**Addendum No. 2**

**City of Coquitlam**

**Tender No. 81832 - Phase 2**
**Cedar Drive Upgrades - Sanitary Pump Station to Gilleys Trail**
(Consists of 44 Pages)

Issue Date: April 25, 2025

# TRAFFIC AND CONSTRUCTION STAGING PLAN
## CEDAR DRIVE UPGRADES - PHASE 2

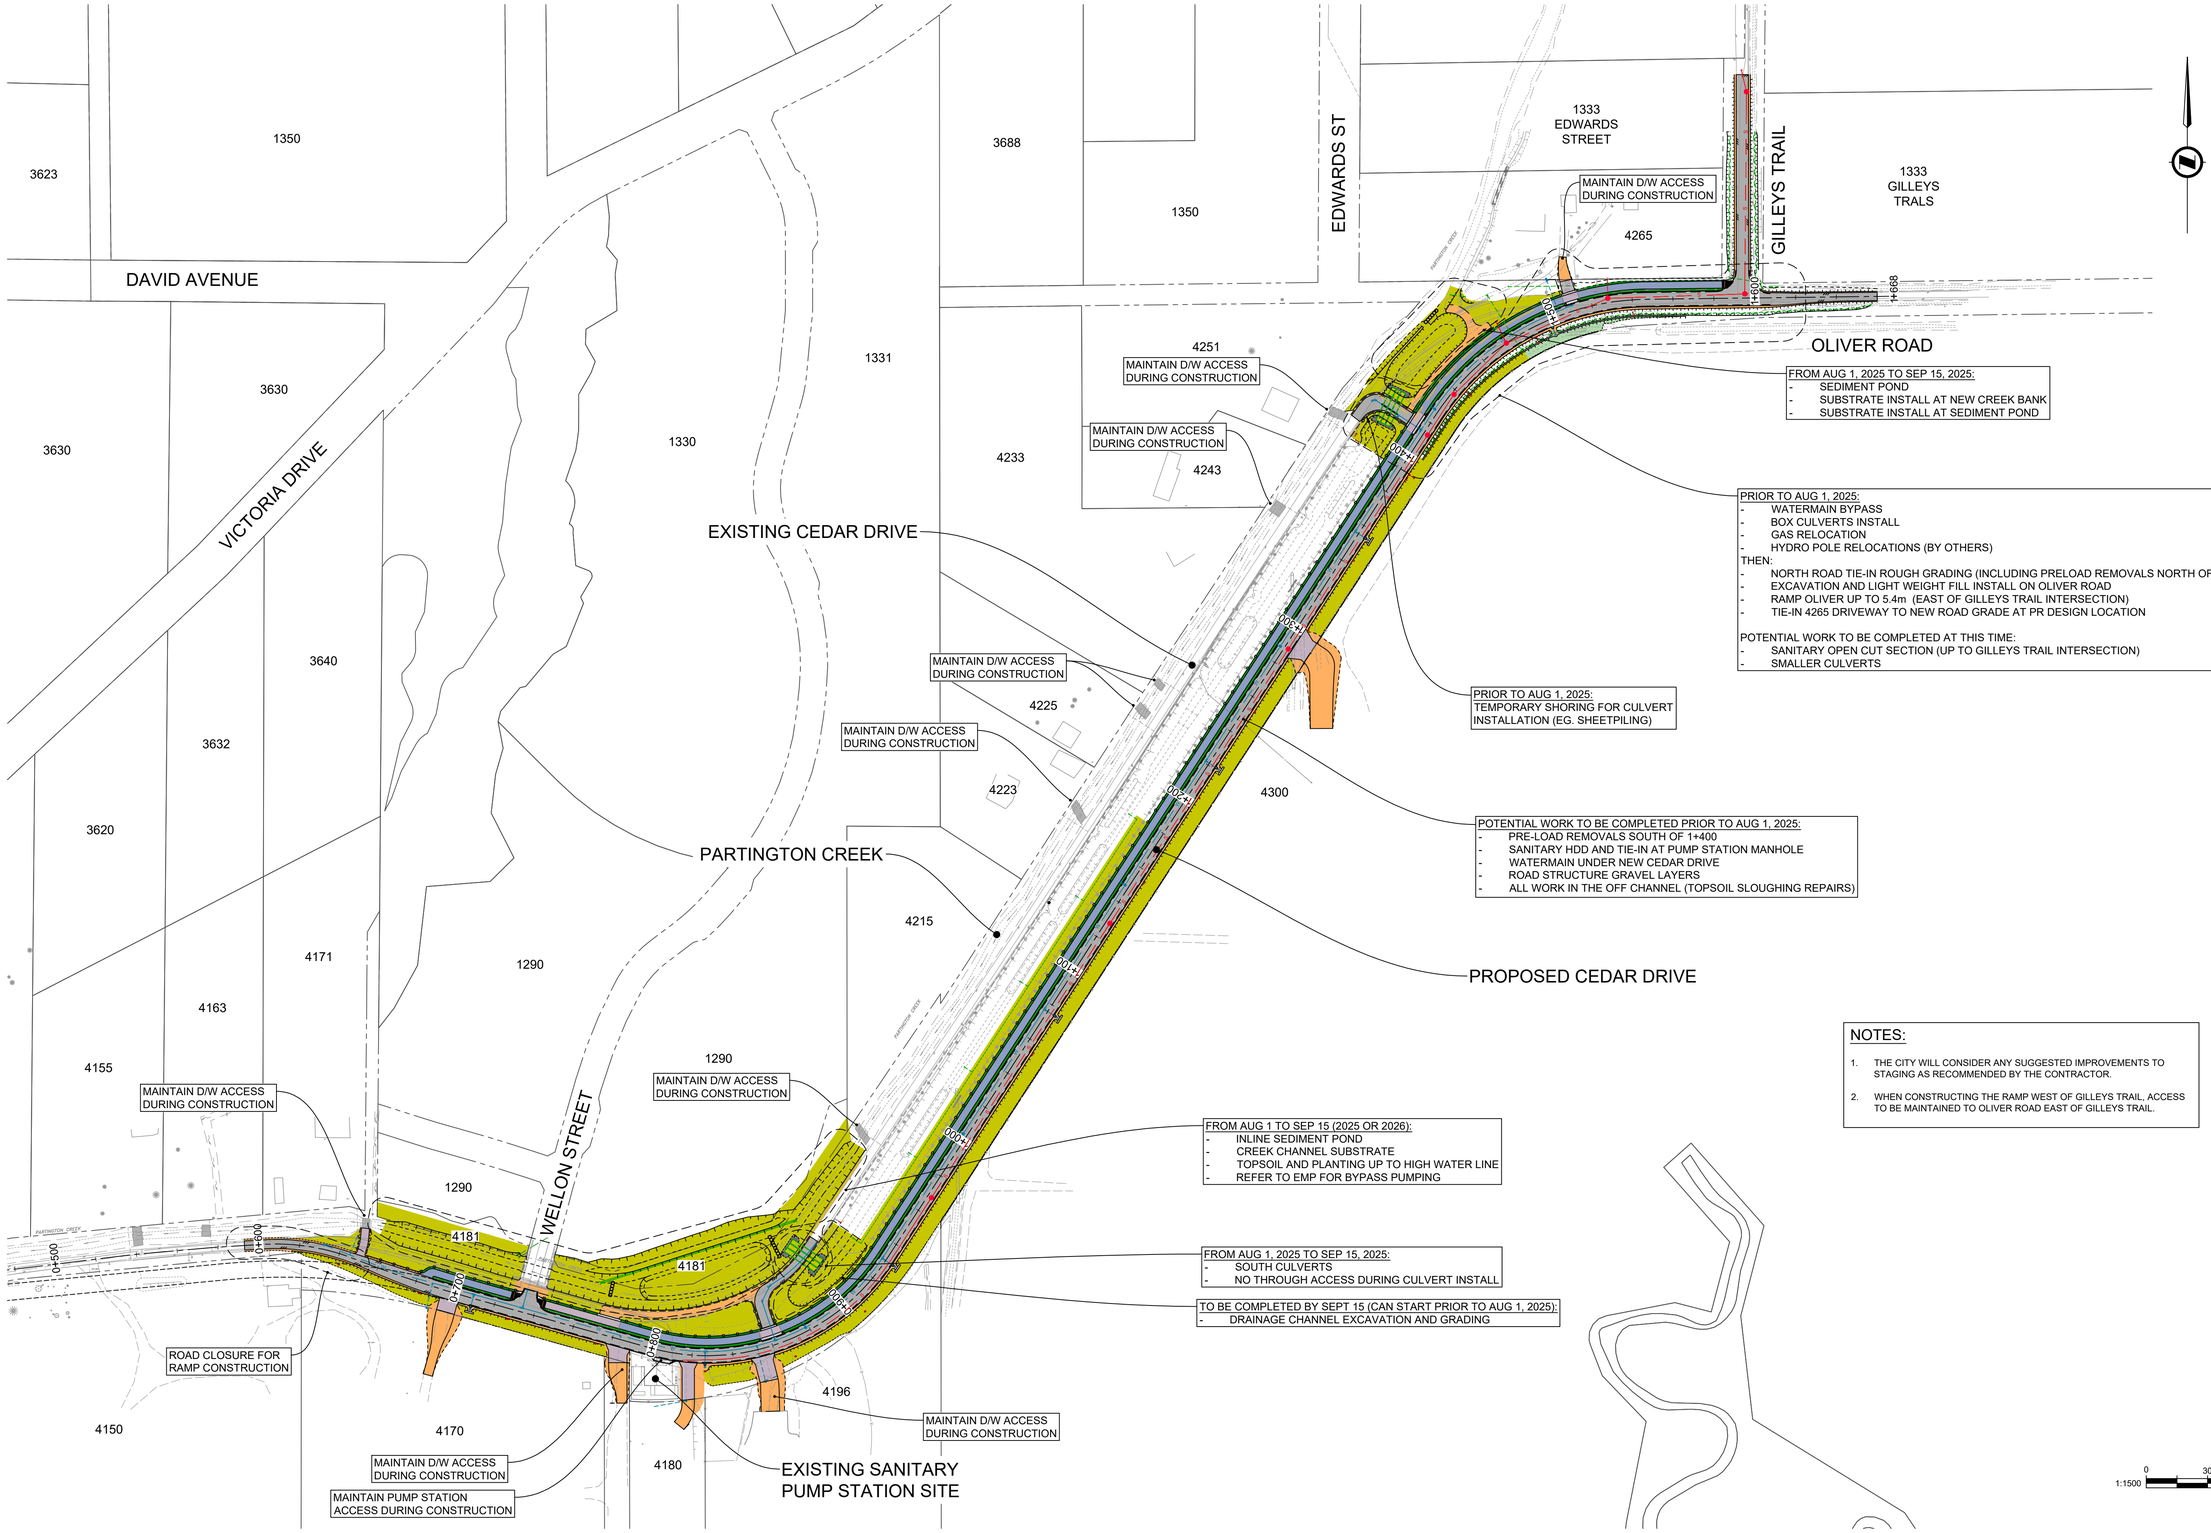
## 6. Refer to: APPENDIX B - Traffic and Construction Staging Plan

### REMOVE: Page TCSP 1

### REPLACE with: Revised TCSP 1

2 / 32 LARGE WOODY DEBRIS TYPE 1 (PARALLEL)
PLAN SCALE 1:40

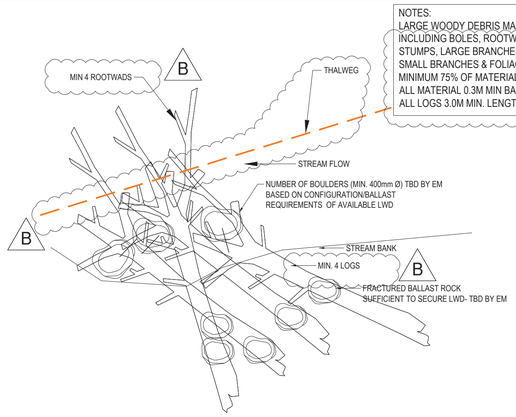
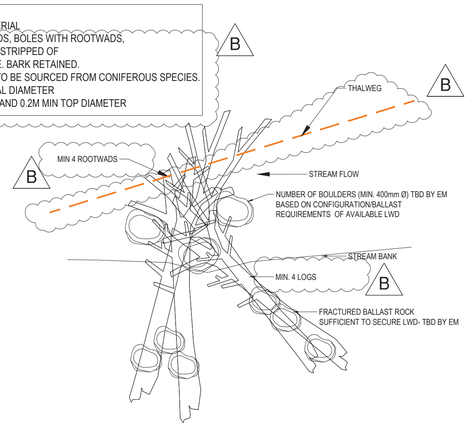
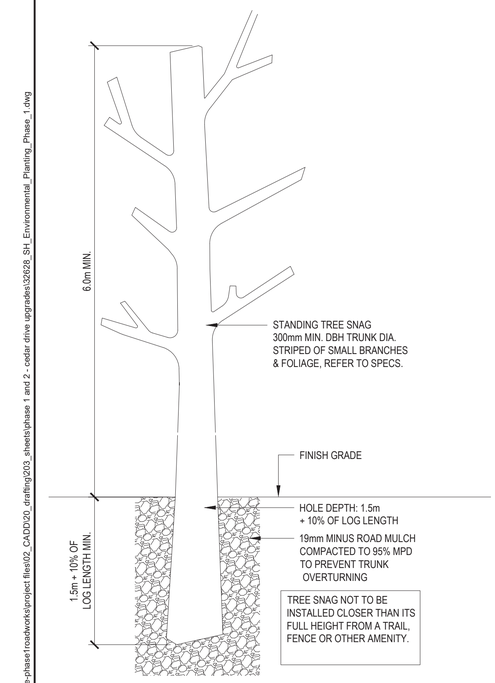
Q11.) Can we use "logs" for the large woody debris? The detail on dwg 32 depicts snags (logs with branches) and notes "with root wads"?

**A11.) As per landscaping detail shown on Contract Drawings.**

5 / 32 SHRUB PLANTING DETAIL
ELEVATION SCALE 1:20

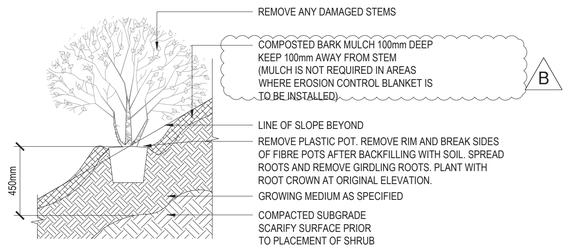
Q7.) Will the bark mulch be 100mm as per dwg 27 note 5.5.4, or 75mm as per 32 detail 5?
